**UTAH DIVISION OF RADIATION CONTROL
ENERGYSOLUTIONS CLIVE LLRW DISPOSAL FACILITY
LICENSE NO: UT2300249; RML #UT 2300249**

**CONDITION 35 COMPLIANCE REPORT; APPENDIX A:
FINAL REPORT FOR THE CLIVE DU PA MODEL**

**SAFETY EVALUATION REPORT
VOLUME 1**

April 2015

Figure 4-5 – Mean radon flux in the embankment

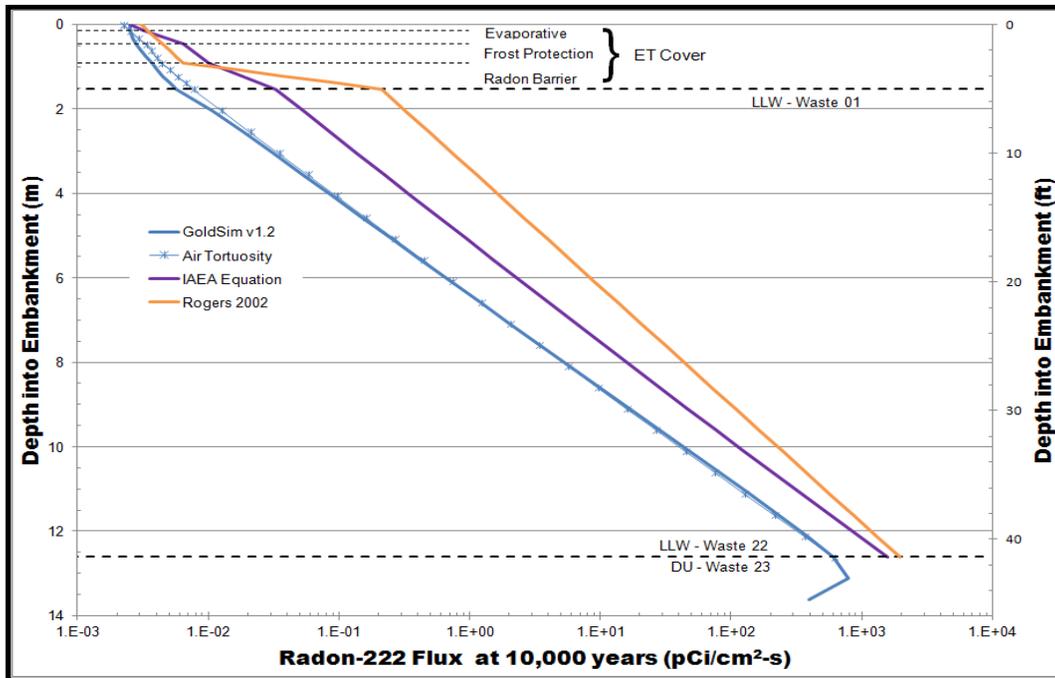
The first thing to notice about Figure 4-5 is that all of the calculated ground surface fluxes are about the same, as shown in Table 4-4 (column 2).

Second, there is a large difference between the GoldSim v1.2 radon attenuation in the ET cover and the ET cover attenuation calculated by either the IAEA Equation or Rogers 2002. For both the IAEA Equation and Rogers 2002, the attenuation provided by the radon barrier layers is clearly shown in Figure 4-5, but for the GoldSim v1.2 there is virtually no attenuation by the radon barrier layers [Table 4-4 shows only an attenuation of 2.3 (i.e., 0.0057 picocuries per

square meter per second [$\text{pCi/m}^2\text{-s}] \div 0.0025 \text{ pCi/m}^2\text{-s}$) for GoldSim v1.2]. In fact, close examination of the Figure 4-5 GoldSim v1.2 curve shows that there is less attenuation per unit thickness in the radon layers than there is in the waste layers. This is due to the different correction factors that EnergySolutions/Neptune calculated and applied (i.e., 0.394 for the waste layers and 0.894 for the radon barrier layers) and Equation (4)'s linear relationship between moisture content and diffusion coefficient. In other words, the increase in the correction factor more than compensated for the increase in the moisture content.

The Air Tortuosity curve in Figure 4-5 agrees well with the GoldSim v1.2 radon flux, indicating that GoldSim v1.2 is performing the calculations as described in the Clive DU PA Model v1.2 documentation (Neptune 2014j).

Figure 4-7 – Ingestion dose at 10,000 years versus infiltration rate

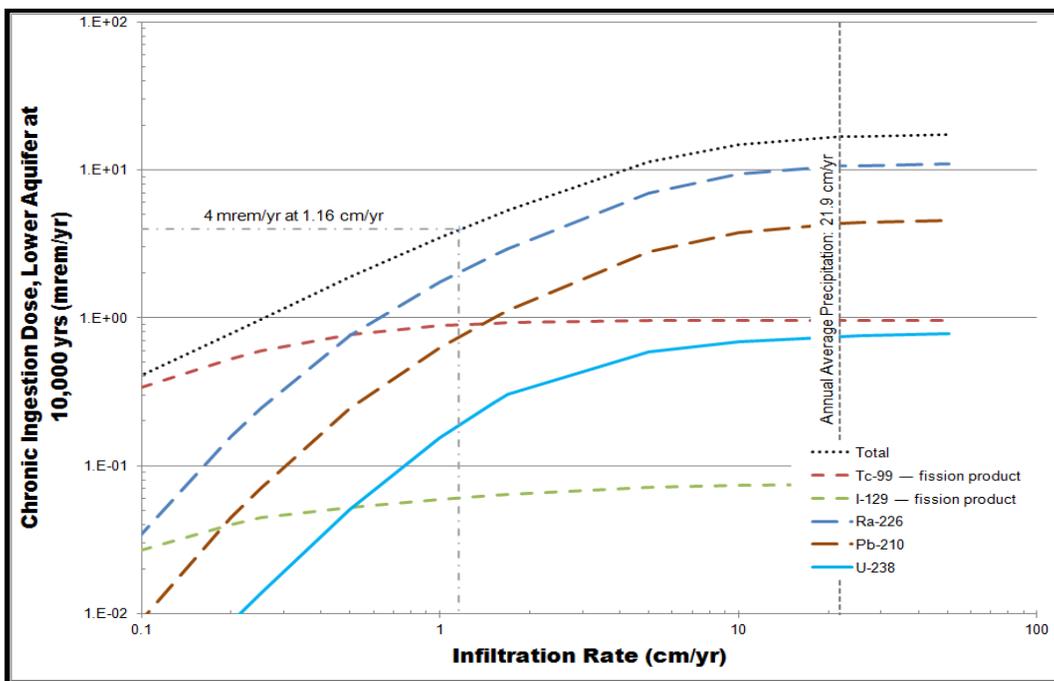
To provide additional perspective on the significance of the groundwater ingestion pathway, DEQ performed a bounding calculation in which it was assumed that the yield from the upper aquifer was sufficient to provide enough water to support a household. As discussed above, this scenario is bounding because the yield from the upper aquifer is not sufficient to support such a scenario. This calculation, which is summarized in Table 3 of Marschke (2015), shows that for time periods up to 10,000 years, a 1:11 dilution of upper to lower aquifer water is necessary to reduce the calculated dose to below the UAC R313-25-19 dose-from-groundwater limit of 4 mrem/yr. However, if disposal of DU-containing recycled uranium is not permitted as proposed in this SER, then the bounding undiluted upper aquifer groundwater ingestion dose is 1.4 mrem/yr, which is below the UAC limit.

As discussed below in Section 4.4.1, there is much uncertainty regarding the infiltration rate that was utilized in DU PA v1.2. Figure 4-7 shows how the calculated chronic groundwater ingestion dose would vary as a function of the infiltration rate, with all other parameters remaining the same as for the Table 4-5 and Figure 4-6 doses. When viewing Figure 4-7, keep in mind that the mean infiltration rate used in DU PA v1.2 was 0.0344 cm/yr (see Section B.7, page B-11). Figure 4-7 shows that, if the infiltration rate exceeds 1.16 cm/yr, the chronic groundwater ingestion dose from this exposure pathway would exceed the UAC R313-25-19 groundwater exposure dose limit of 4 mrem/yr.

Figure 5-1 – Mean radon flux above depleted uranium

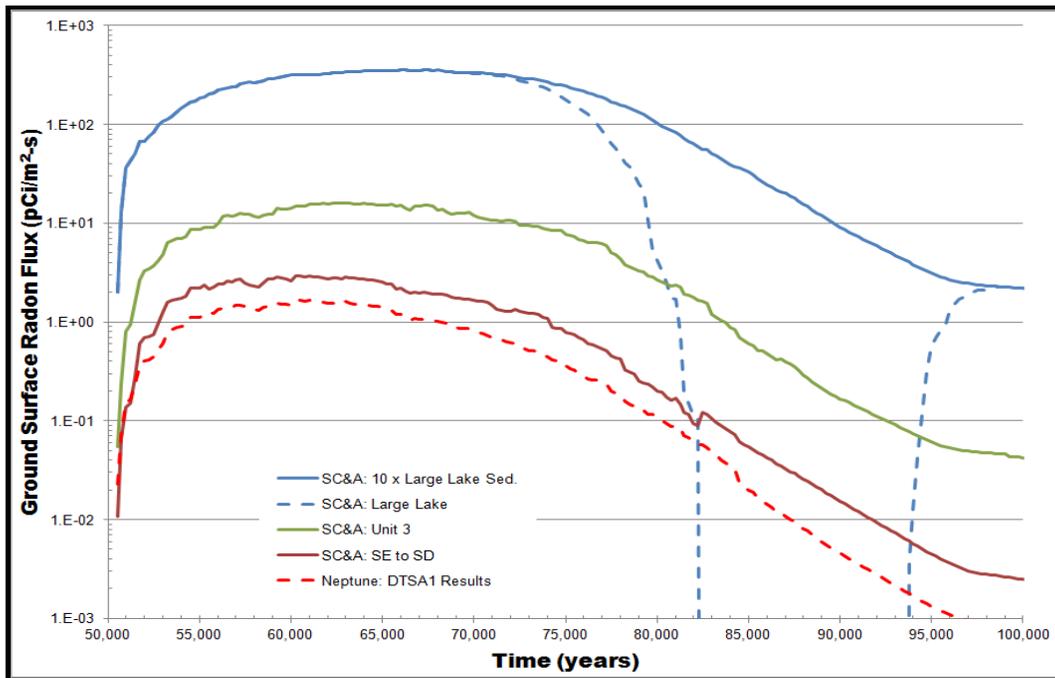
The current EnergySolutions/Neptune DTSA GoldSim model (Neptune 2015a) calculates the radon flux above the embankment regardless of the presence or absence of a lake. In reality, if a lake is present, the lake water would attenuate the radon such that the flux on the lake surface would be negligible. For example, an early return of a Large Lake could significantly reduce peak mean radon flux. The last SC&A case (SCA: Large Lake) demonstrates this effect utilizing the revised DTSA GoldSim model and shows that peak mean radon flux would occur sufficiently early so as not to be affected by the return of a Large Lake. Because of the short duration of Intermediate Lakes (i.e., a mean of 500 years [Neptune 2014e, Table 1]), which is on the same order as the GoldSim time step, this effect has conservatively not been modeled for Intermediate Lakes.

The Figure 5-1 dashed blue curve (SC&A: Large Lake) is the same as the SC&A: 10x Large Lake case (the solid blue curve) except that ground surface radon flux has been set to zero whenever a Large Lake is present. Because their durations are about the same length as the time-step used in the GoldSim model, it was not feasible to set the radon flux to zero during the presence of an Intermediate Lake. Since the peak mean radon flux occurs following the first Intermediate Lake, setting the flux to zero during the presence of a Large Lake has no impact on the peak mean radon flux, as shown by Figure 5-1.

Figure 5-3 – Comparison of standard error to standard deviation

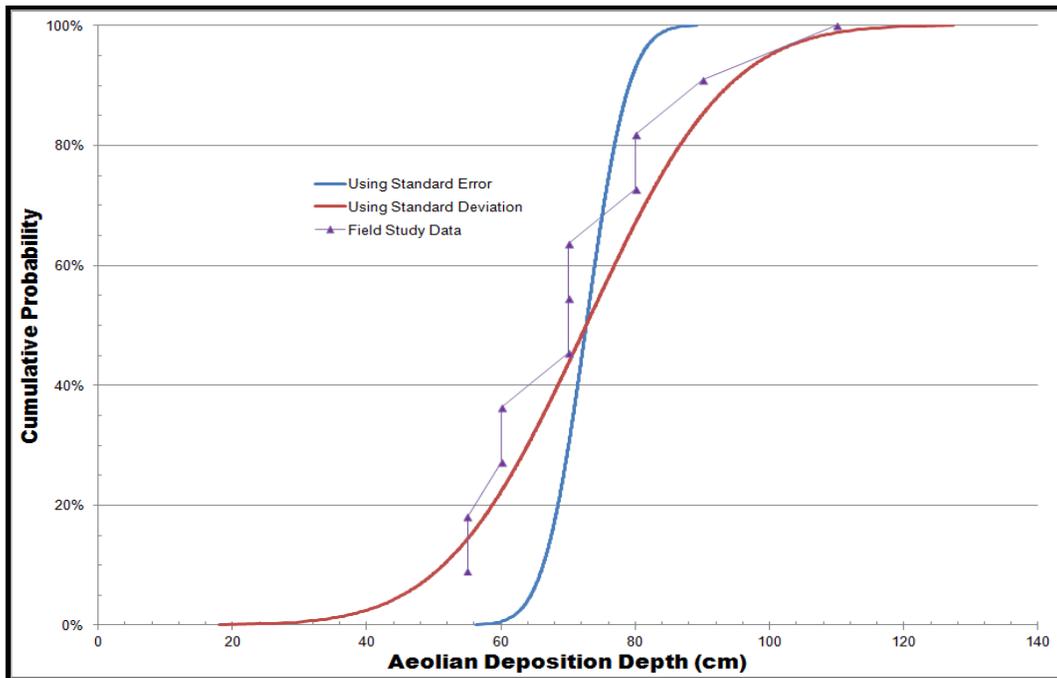
Figure 5-3 shows the impact that using the standard error instead of the standard deviation would have on the aeolian deposition depth. For comparison purposes, Figure 5-3 also shows the distribution of the 11 depths (i.e., silt thicknesses) that were obtained from the field studies (Neptune 2015b, Table 2). When compared to the standard deviation, the standard error of the mean tends to remove the extremes from the analysis. If the measurements were of annual deposition rates, where there is expected to be a wide variation from year to year, then the use of the standard error of the mean would be appropriate. However, the measurements that were taken are of the total sedimentation depth accumulated over thousands of years, which accounts for any year-to-year fluctuation in the sedimentation rate. Thus, the use of the standard deviation is believed to be appropriate.

Figure 5-3 shows that the “tails” of the standard error distribution are much shorter than the “tails” of the standard distribution. In fact, the aeolian deposition depth calculated from the standard error distribution never reaches the maximum depth of 110 cm that was measured in the field studies. It is believed that the Figure 5-3 standard deviation curve is a much better match to the field study data than the Figure 5-3 standard error curve.

Figure 5-4 – Unit 3 and Unit 4 moisture content

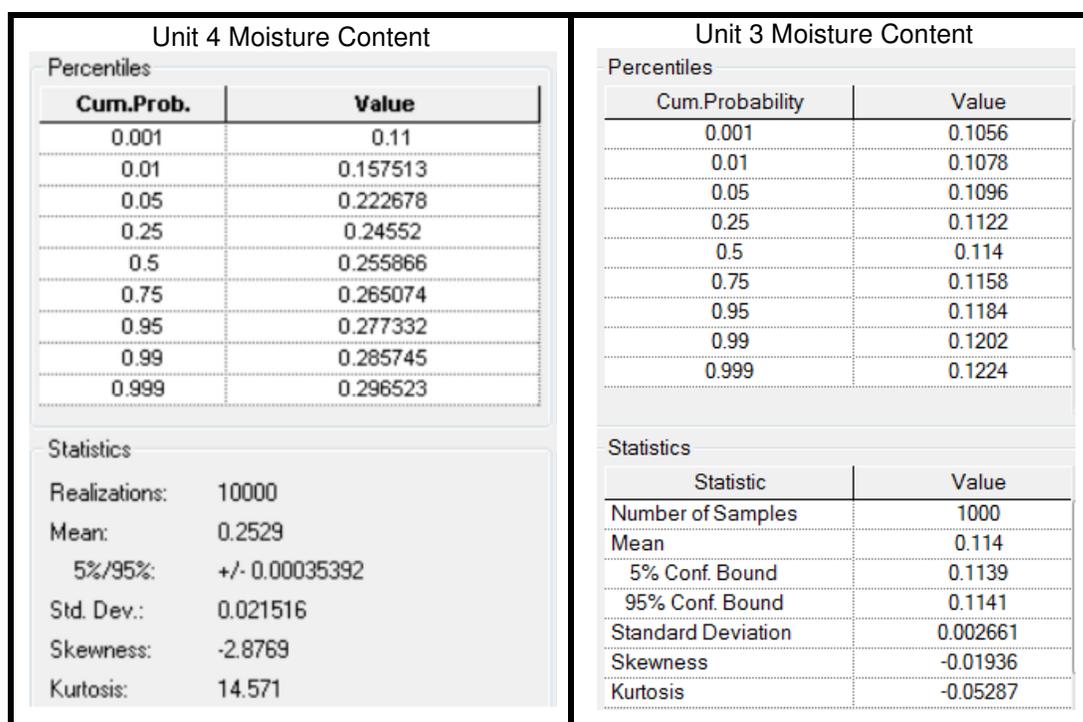
A major difference between Unit 3 and Unit 4 material is their moisture content distributions. Figure 5-4 shows that the Unit 4 mean moisture content (taken from Neptune 2014n, Figure 1) is 0.2559, while the Unit 3 mean moisture content is only 0.114 (taken from GoldSim). This is important because the radon diffusion coefficient is related to the moisture content, such that the higher moisture content of the Unit 4 material results in a reduced radon flux at the ground surface when compared to the Unit 3 material.

When SC&A changed the DU layers and the layers immediately above the DU from Unit 4 material to Unit 3 material and re-ran GoldSim, the ground surface radon flux increased by about a factor of 5.5 to 16.1 pCi/m²-s, as shown in Table 5-1.

Figure 5-9 – DEQ-calculated fraction of GWPL for various radionuclides as a function of time based on all DU PA inventory at the 90-foot well (unconfined aquifer)

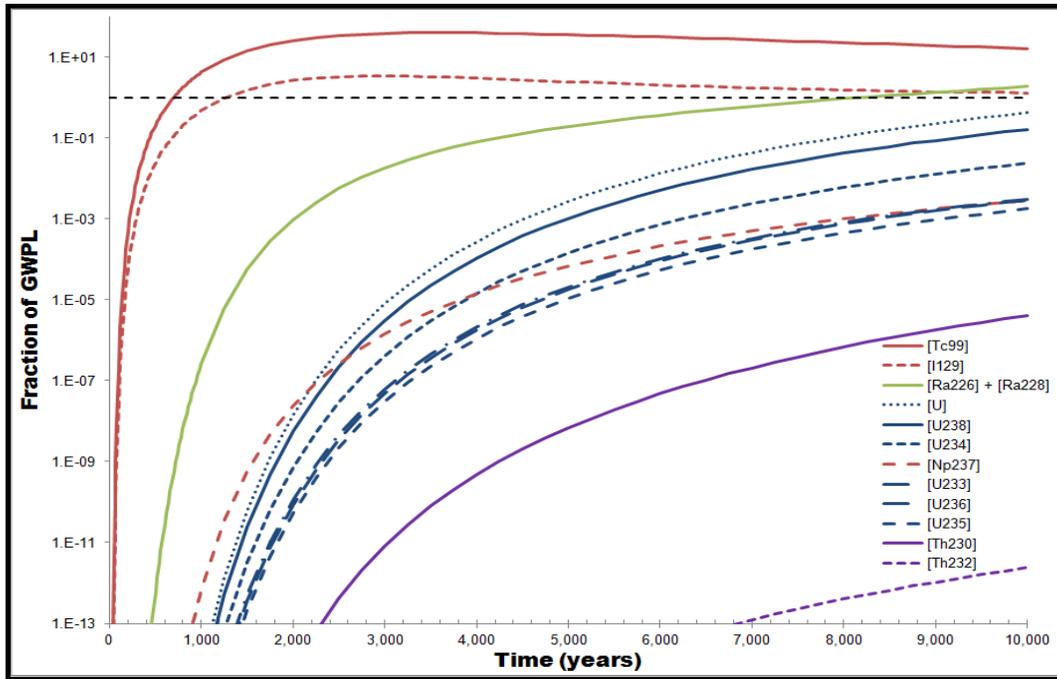
Even though Figure 5-9 shows that after the 500-year GWQ Permit evaluation period some of the GWPLs are exceeded, the groundwater ingestion analysis discussed in Section 4.2.2 indicated that the UAC Rule R313-25-20 groundwater pathway dose limit of 4 mrem/yr is not exceeded.

Figure 5-10 – DEQ-calculated fraction of GWPL for various radionuclides as a function of time based on inventory of clean DU waste only (fission products absent) at the 90-foot well (unconfined aquifer)

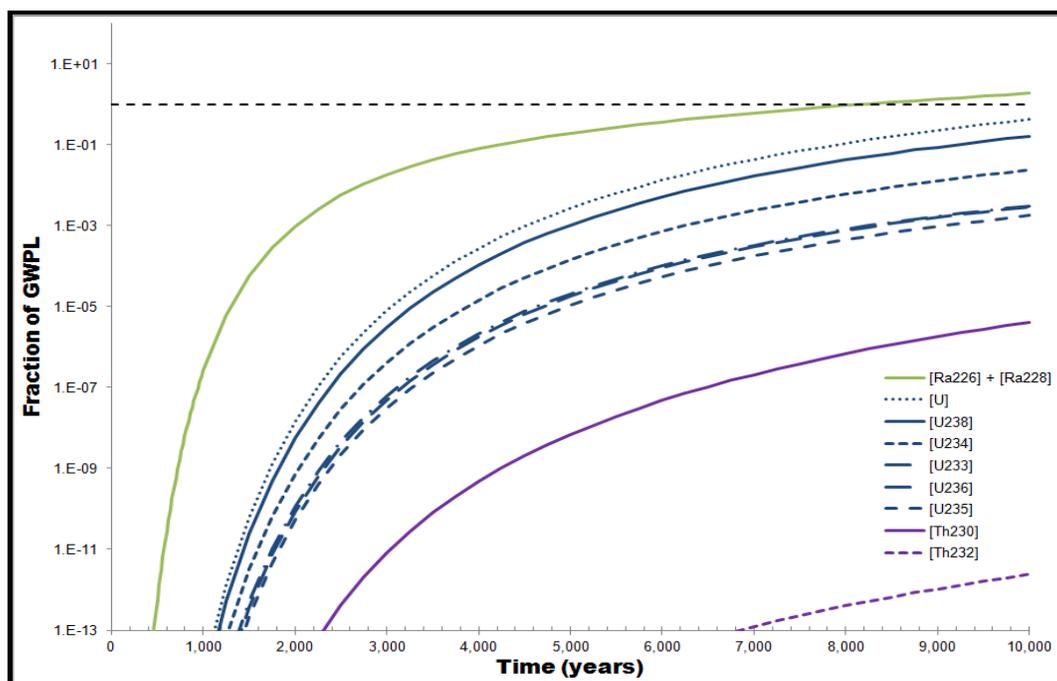
For the second case, DEQ assumed that only clean DU (no fission or activation products) was emplaced. The results are shown in Figure 5-10. At about 8,500 years, the Ra-226 + Ra-228 concentration exceeds the GWPL of 5 pCi/L, while at 10,000 years the Ra-226 + Ra-228 concentration is 21 pCi/L. Thus, the radium GWPL of 5 pCi/L in the upper, unconfined aquifer would be exceeded at the 90-foot buffer zone well, but not until long beyond the 500-year GWPL evaluation period. Based on the EnergySolutions Round 2 Response to Interrogatory CR R313-25-19-182/2: Groundwater Exposure Pathways (ES 2014a), the dilution factor [as calculated in EnergySolutions (2014e) using the Dupuit-Thiem equation] between the upper, unconfined aquifer and the lower, confined aquifer is 3.28E8-03, which would result in radium

While the Ra-226 + 228 concentration will exceed the GWPL in the upper aquifer after about 8,000 years, the 500-year compliance point specified in Utah GWQ Permit No. UGW450005 is met, as discussed previously. In addition, the maximum ingestion dose within the first 10,000 years from Ra-226 is 2.32E-03 mrem/yr and from all radionuclides is 9.24E-02 mrem/yr. Clearly, these values are well below the exposure limit for members of the general public—4 mrem/yr TEDE from groundwater as specified in UAC R313-25-20.
